Our ref: CG/38181B

**79 Avenue Road – Review of construction sequence and development updates**

**Plate 1. Proposed development layout from CGL GMA Rev 1 vs. Knight Build July 2021 plans**

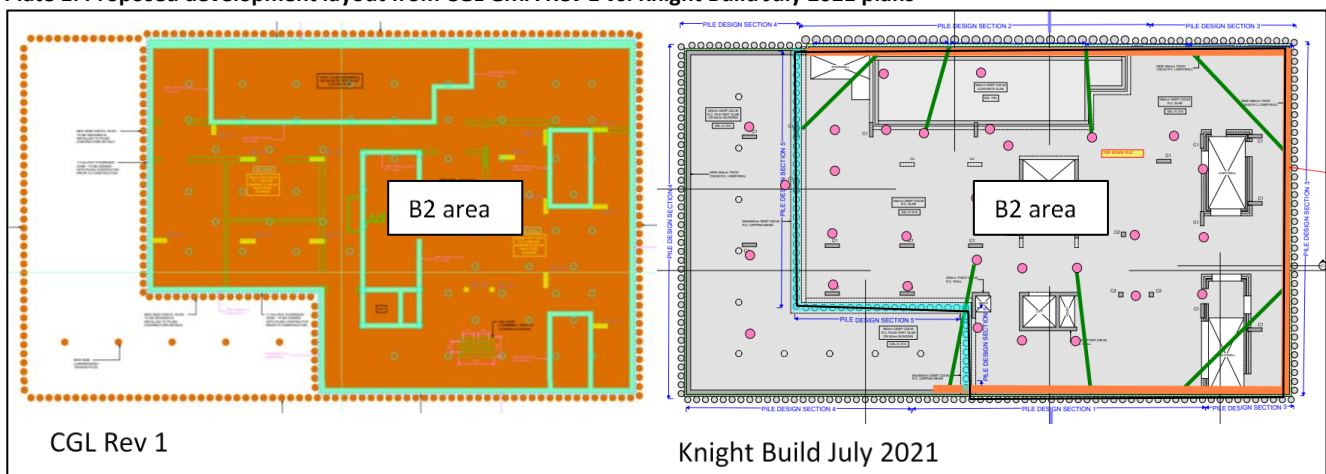
It is proposed to demolish the existing residential building on the site and replace this with the a new residential building, with a basement level (basement B1), a plant room level (basement B2) and three above ground storeys on piled foundations. The proposed development layout assessed in the CGL GMA Rev 1 is presented along side the current proposed development layout in Plate 1 below. There has been no significant change in layout since the CGL GMA Revision 1.
